LOCATION SURVEY

5409 TALON COURT 5TH ELECTION DISTRICT HOWARD COUNTY, MD.

SITE INSPECTION SHEET

Re: 40' x 30' detached 3 car garage --- request for placement variance for permit # B00158995

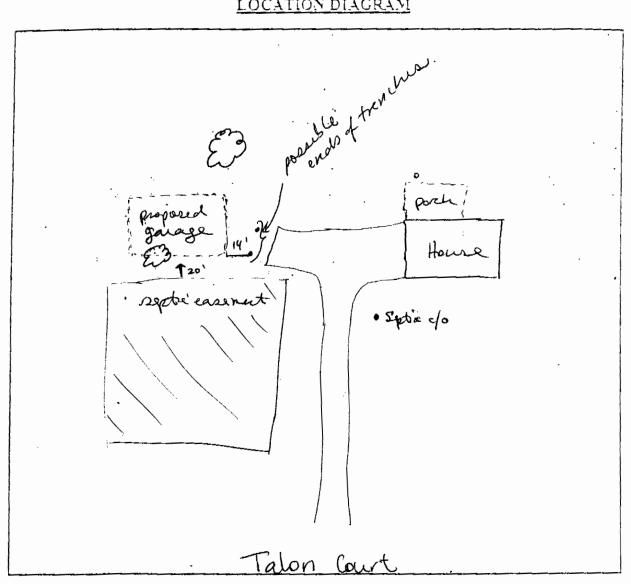
Sara, 5/1/06	ended difference in a model of defendance of the second of
The variance is approvable, 148t separation garage to drainfield, but the site plan needs: (a) Must be to scale (b) Must included garage to propeling sof bucks. (c) Site plan must indicate that traffic bearing 10.25 are required for the lossessation pipes if they are located in the driveway.	
Sec nc to discuss.	
1 in	
	n delen a e e e e e e e e e e e e e e e e e e
